Model: AG-P1		Date: 14-Jul-10	No.: RG178108
Subject: Stacker Max Capacity Adj for Jam Prevention		Prepared by: Hiroaki Matsui	
From: PPBG Service Planning Dept.			
Classification:	<input checked="" type="checkbox"/> Troubleshooting	<input type="checkbox"/> Part information	<input type="checkbox"/> Action required
	<input type="checkbox"/> Mechanical	<input type="checkbox"/> Electrical	<input type="checkbox"/> Service manual revision
	<input type="checkbox"/> Paper path	<input type="checkbox"/> Transmit/receive	<input type="checkbox"/> Retrofit information
	<input type="checkbox"/> Product Safety	<input type="checkbox"/> Other (      )	<input checked="" type="checkbox"/> Tier 2

Model: High Capacity Stacker SK5000		Date: 27-May-14	No.: RD364001
Subject: Parts catalogue correction – Coupling bracket		Prepared by: T. Miyamoto	
From: 1st PP Tech Service Section, PP Tech Service Dep.			
Classification:	<input type="checkbox"/> Troubleshooting <input type="checkbox"/> Mechanical <input type="checkbox"/> Paper path <input type="checkbox"/> Product Safety	<input checked="" type="checkbox"/> Part information <input type="checkbox"/> Electrical <input type="checkbox"/> Transmit/receive <inpu

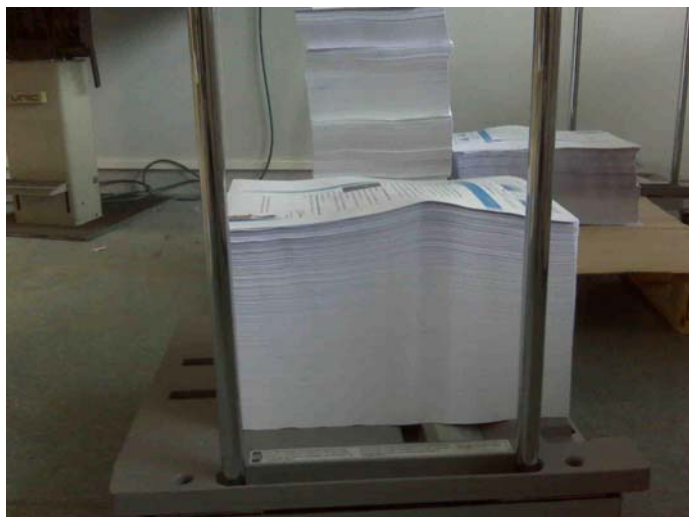
1. Curled sheets (Curls cannot be removed completely by the De-curl unit.)
2. Lump(s) formed in the stacked sheets (as in the photo below) caused by a particular area of the image containing high toner density
